Report of Staff Recommendation

File No.: 9-A-22-TOB

Applicant: KARNS FIRE DEPT.

Request: BUILDING PERMIT

Site Layout and Paving Plan

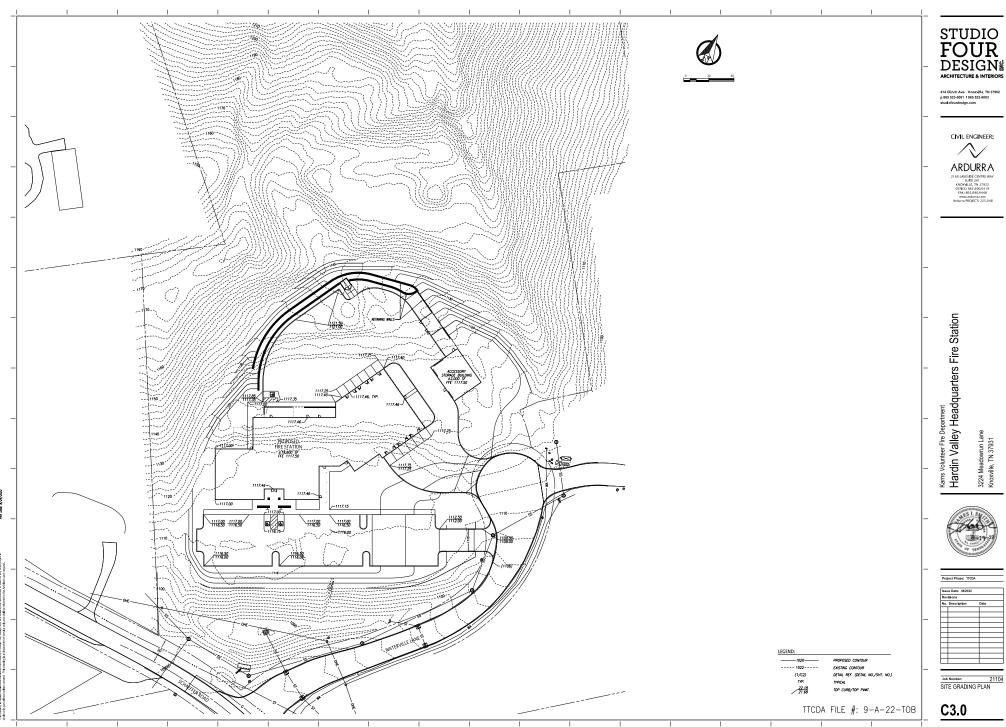
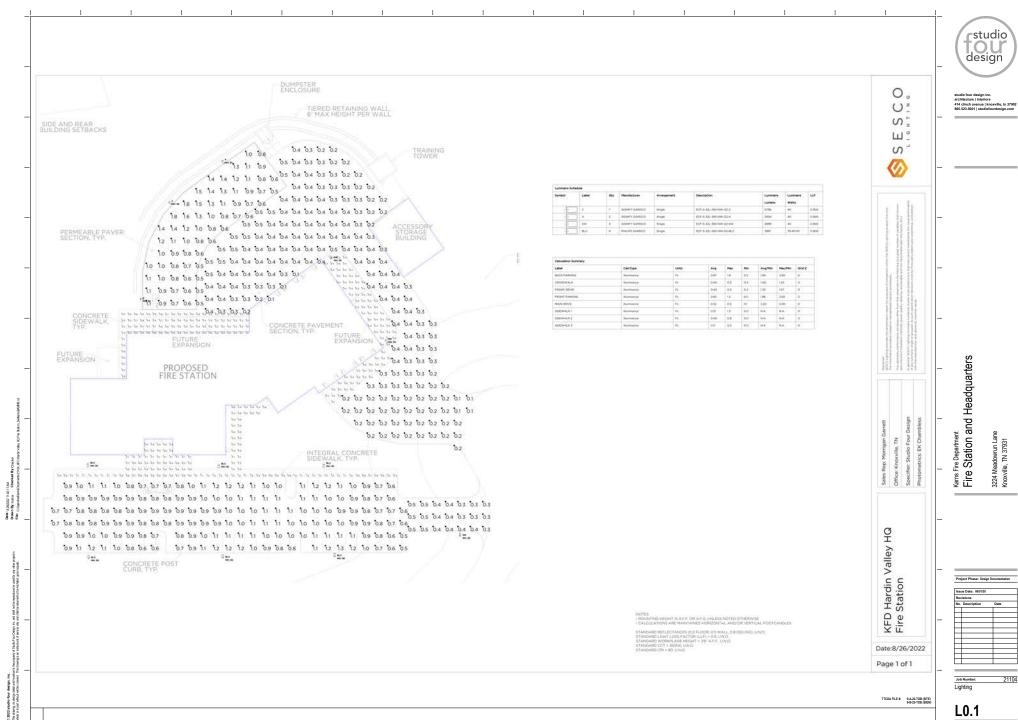
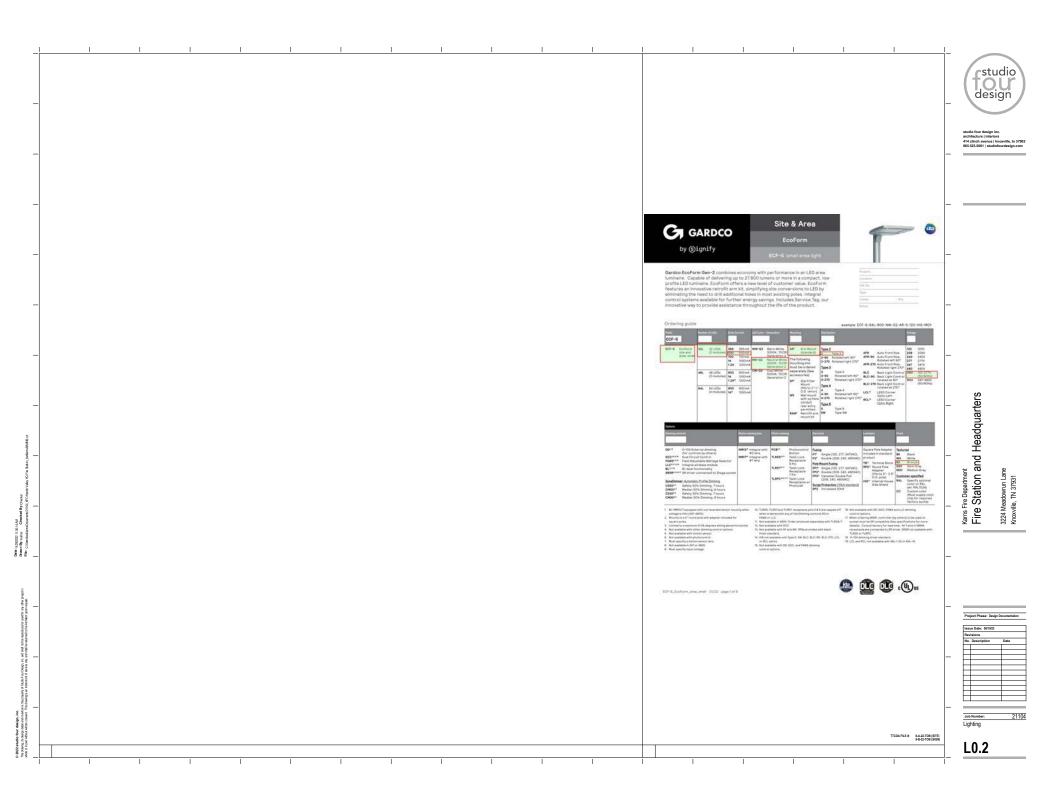
6) Parking was calculated using the initial building square footage of 19,600 square feet, which in the TTCDA, would allow a maximum of 69 spaces. The plans propose 69 spaces and are therefore in compliance with the Guidelines. An additional 6 spaces could be accommodated

adjacent to the existing spaces, and this would be below the maximum number of spaces allowed for the project's planned expansion to 21,525 square feet (75 spaces).

7) There are three large garage doors facing Waterville Lane to provide an easy exit for fire trucks. These are angled away from Schaeffer Road and situated farther back than the main

building, thereby minimizing the visibility of the doors from the main thoroughfare. Landscaping and a berm at the southern edge of the front parking area will also lessen the visibility of the doors.

Landscape Plan

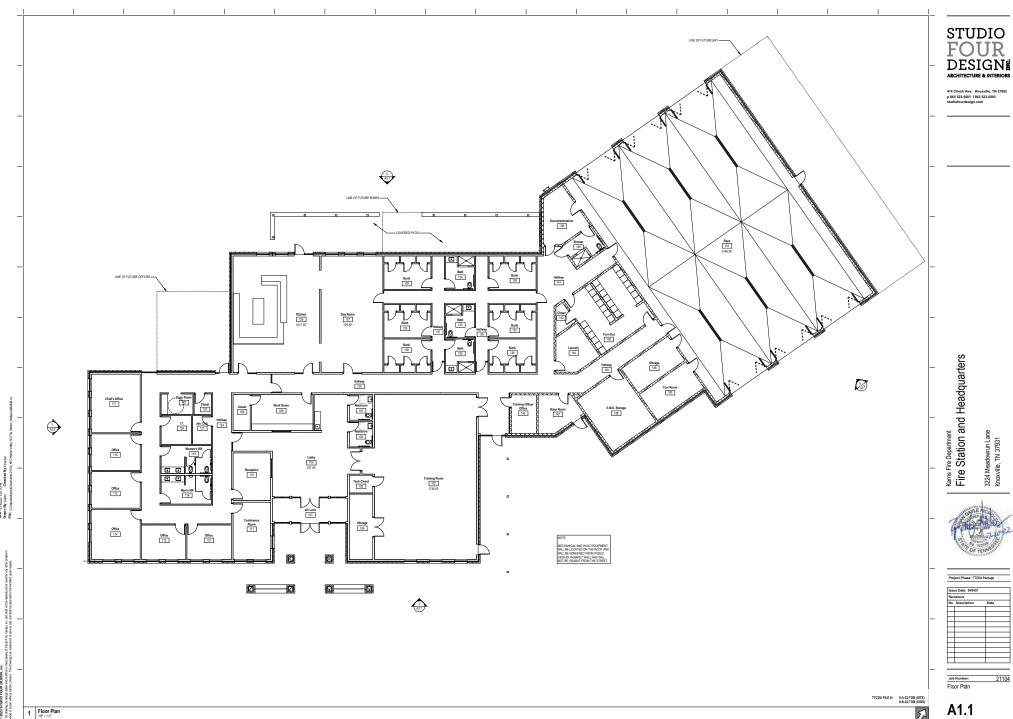
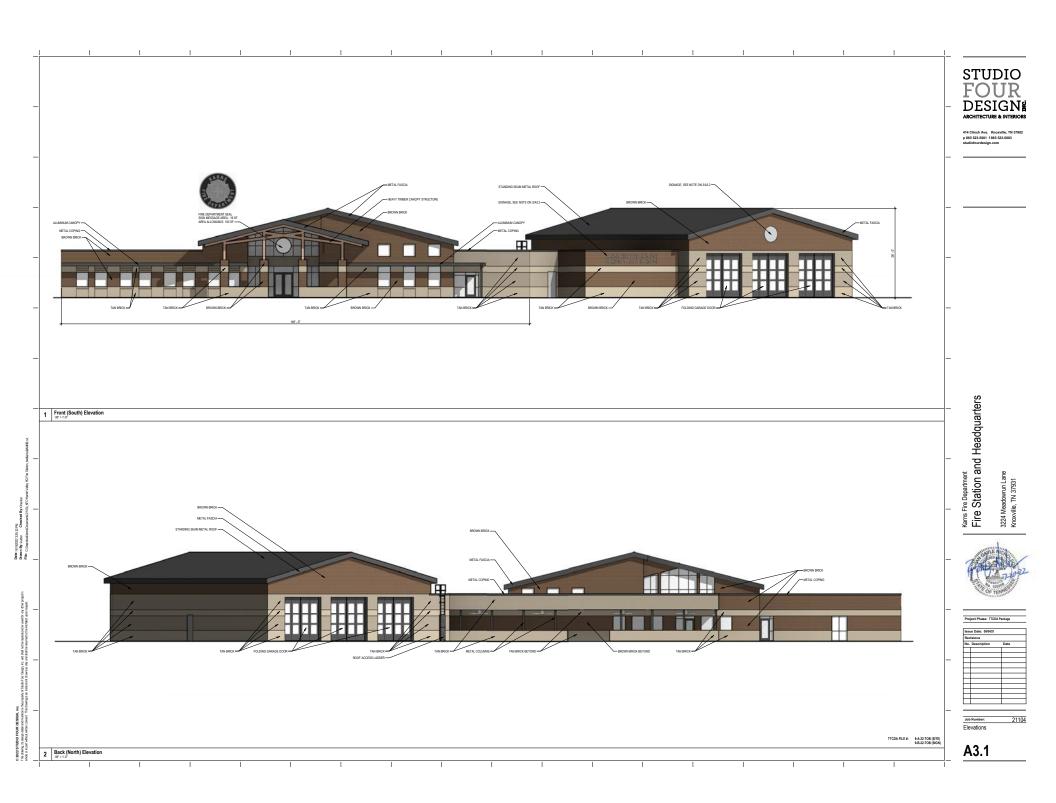
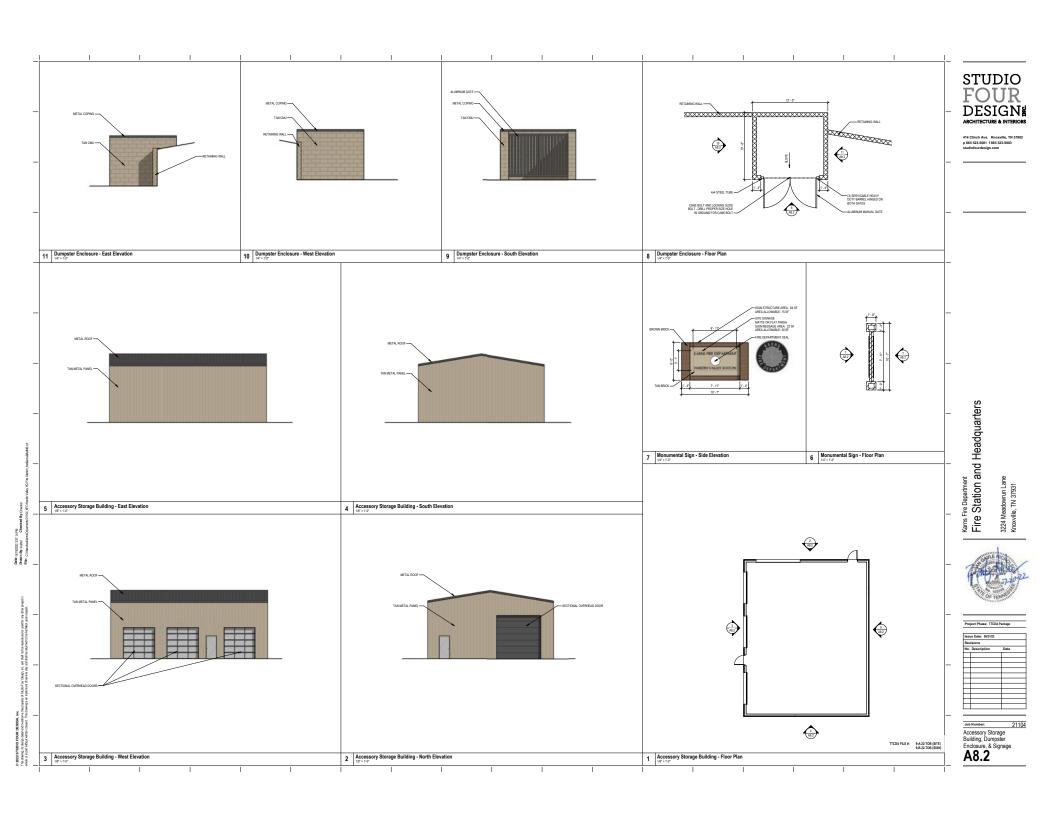
- 8) The landscape plan meets the landscaping requirements of the TTCDA Guidelines. The notes on Sheet L100 provide a detailed description of compliance with the applicable standards.
